Public Service Commission

June 18, 2021

The Reclamation Division has reviewed DWC's June 2, 2021 response to our May 25, 2021 review of Revision 32 to Permit KRSB-8603. The following items must be addressed prior to recommending Commission approval and Revision 32 must be approved prior to Renewal No. 7.

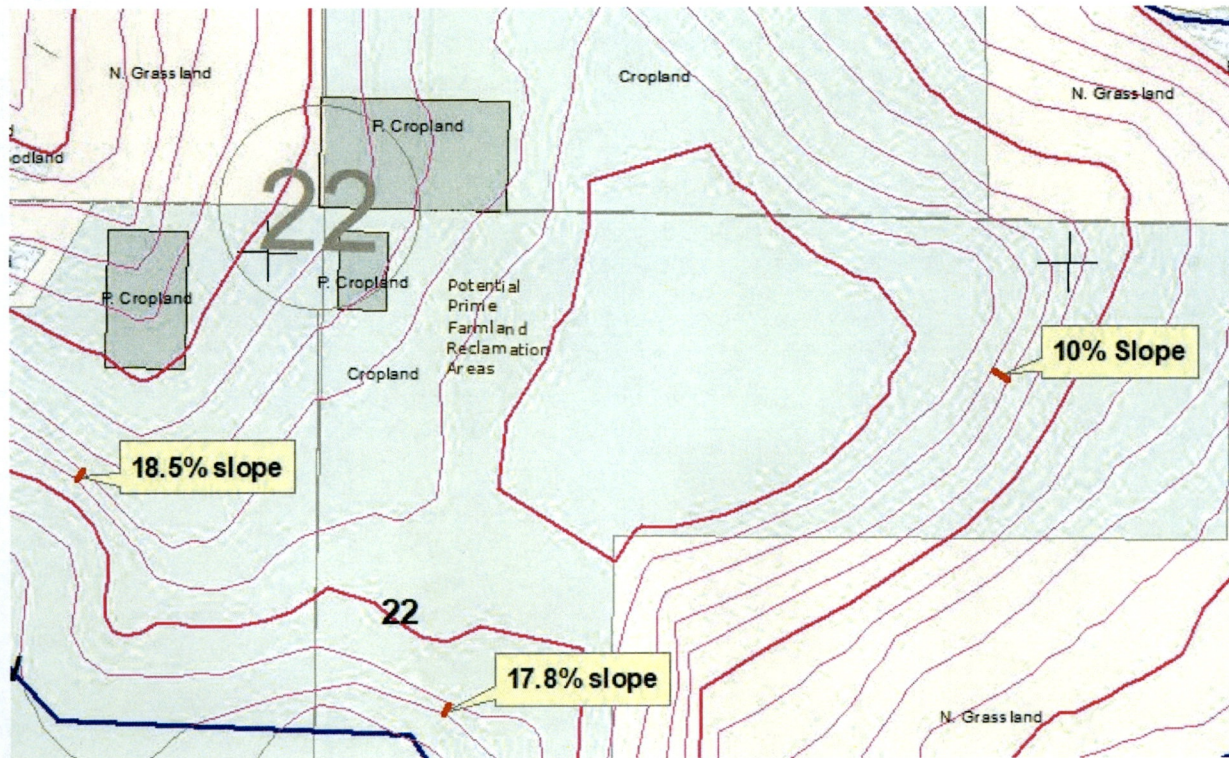
11. The Reclamation Division has identified three small areas in the S1/2 of Section 22 where the slope of reclaimed cropland exceeds 9 percent. The image below depicts the areas of concern. Please revise the Post Mining Topography map, Exhibit 3.5.3, to reduce slopes in these areas to less than 9 percent. (GAW)
